# PERMIT CHANGE TRACKING FORM

DATE RECEIVED	4/13/95	PERMIT NUMBER	ACT/015/009
Title of Proposal:	Sewage System	PERMIT CHANGE #	95C
Description:	Connection with Cottonwood Mine	PERMITTEE	Pacificorp
		MINE NAME	Trail Mtn. Mine

**RE: TRAIL MOUNTAIN MINE SEWAGE SYSTEM MODIFICATION, PACIFICORP,  
TRAIL MOUNTAIN MINE, ACT/015/009, EMERY COUNTY.**

TO: Joe Helfrich, Permit Supervisor *JH*  
FROM: Wm. J. Malencik, Reclamation Specialist *WJM*  
RE: Sewage System Amendments, Trail Mountain Mine,  
ACT/015/009-95C, Folder #2, and Cottonwood Mine,  
ACT/015/019-95C, Folder #2, PacifiCorp Electric  
Operations, Emery County, Utah

FIGURE 1

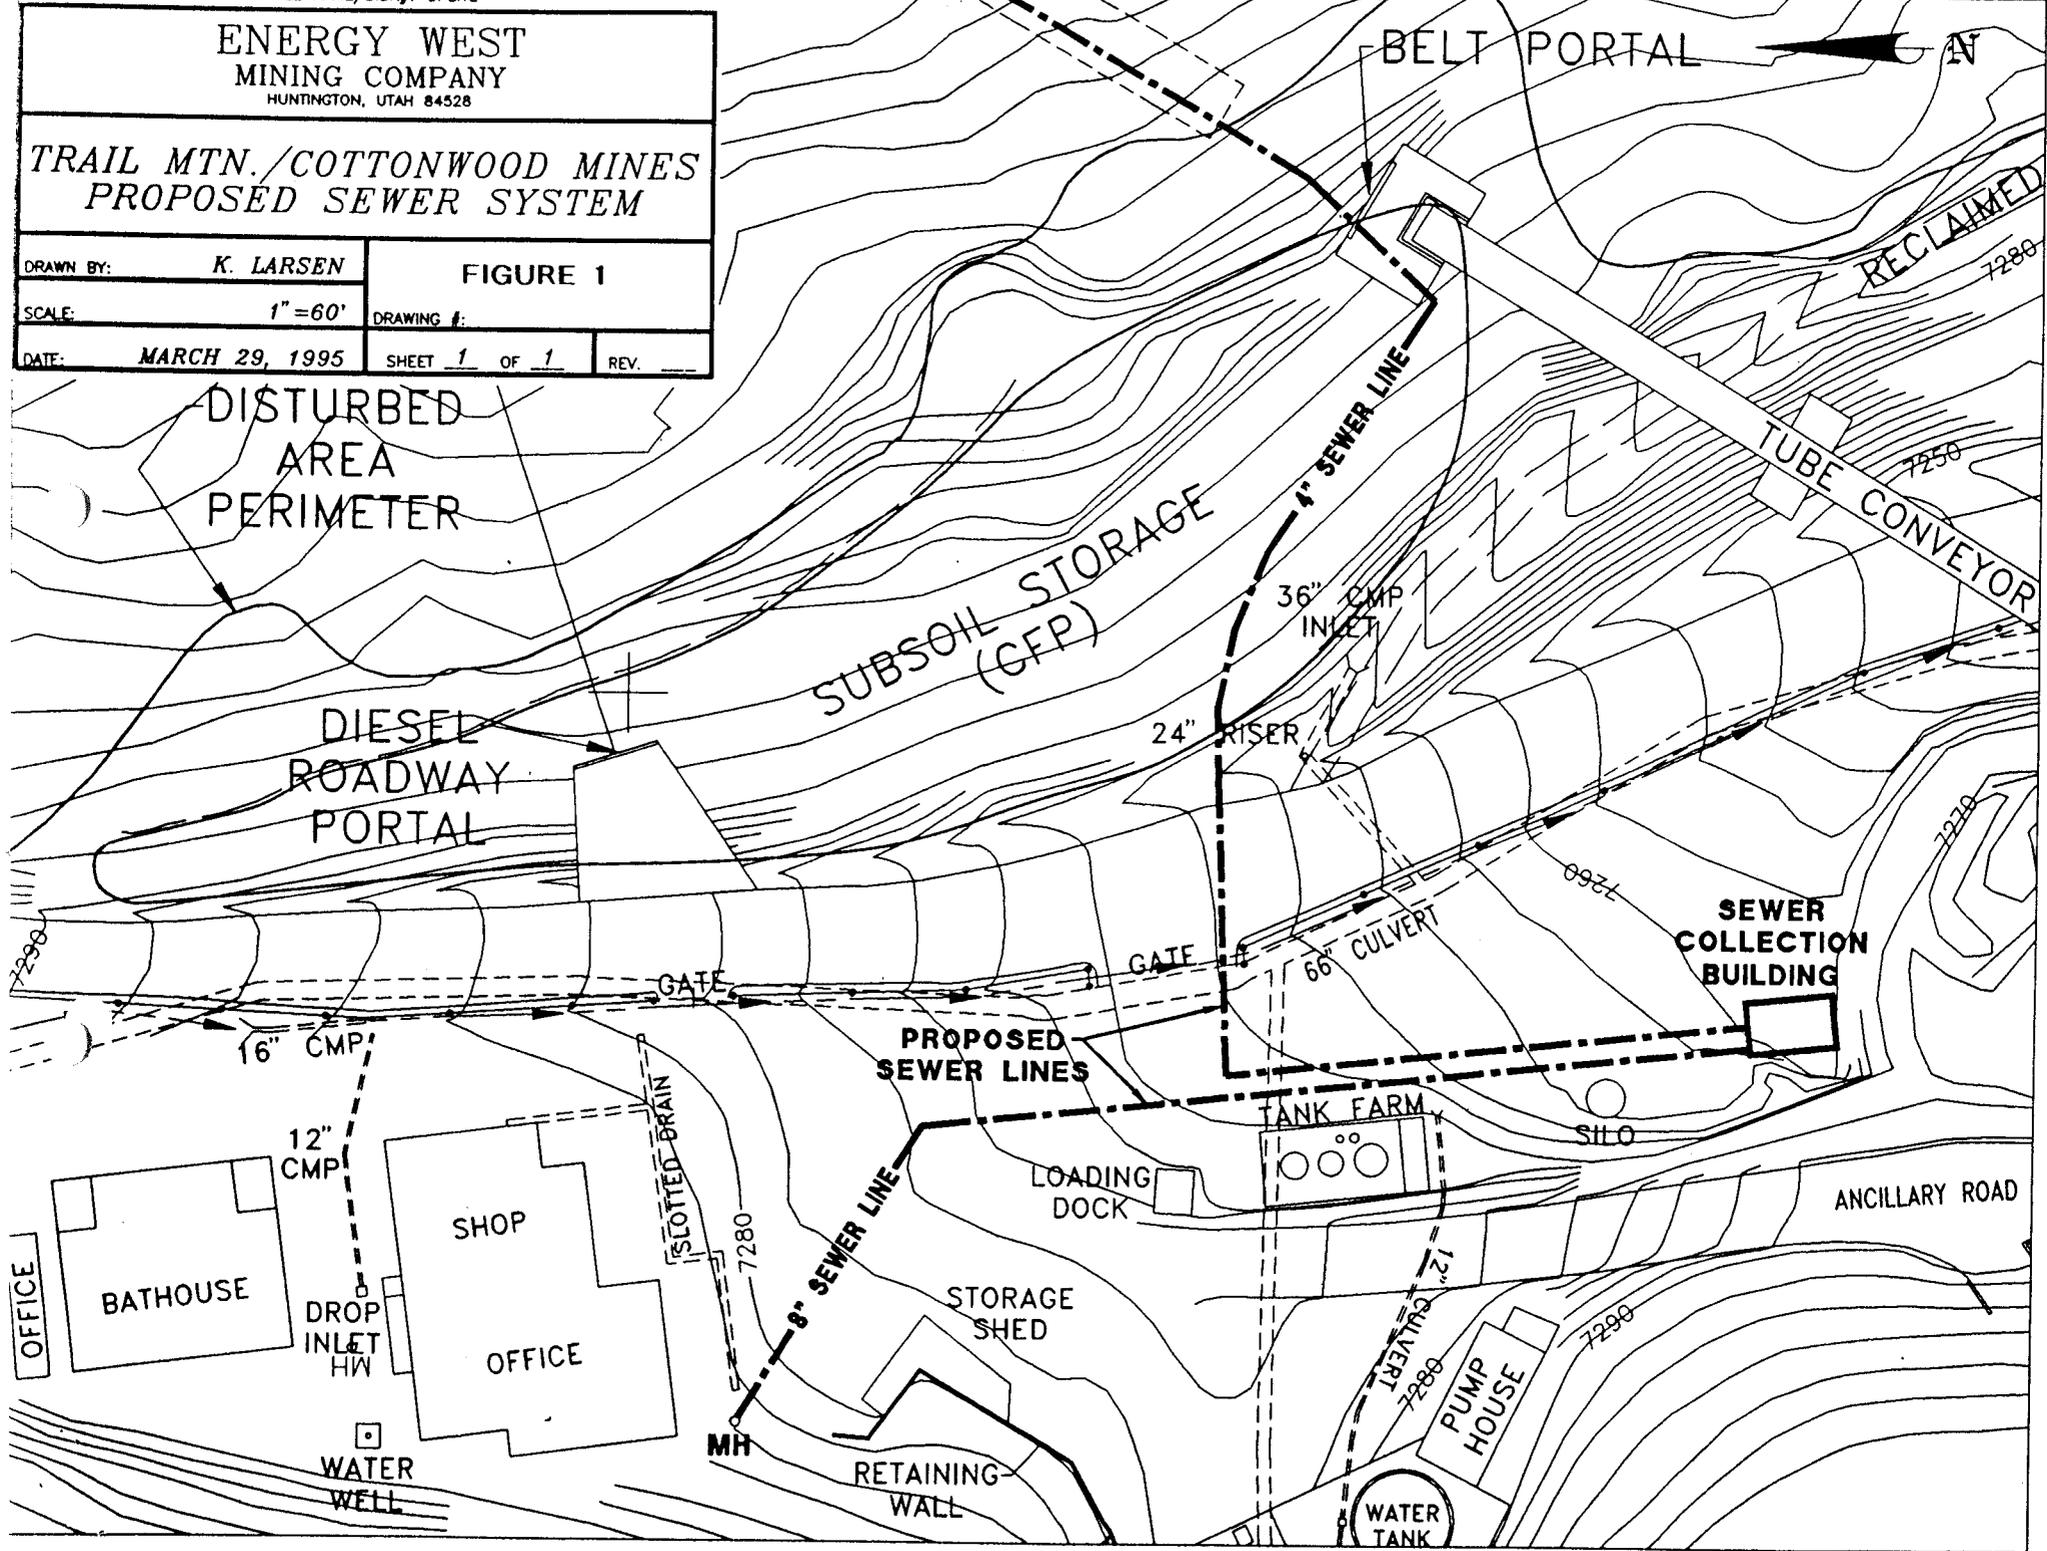
- Trail Mountain #9 map, Figure 1, dated 3/29/95, sheet 1 of 1 shows the sewer line, collection building/pumphouse, Emery County Road and the intertie with the Cottonwood permit area.
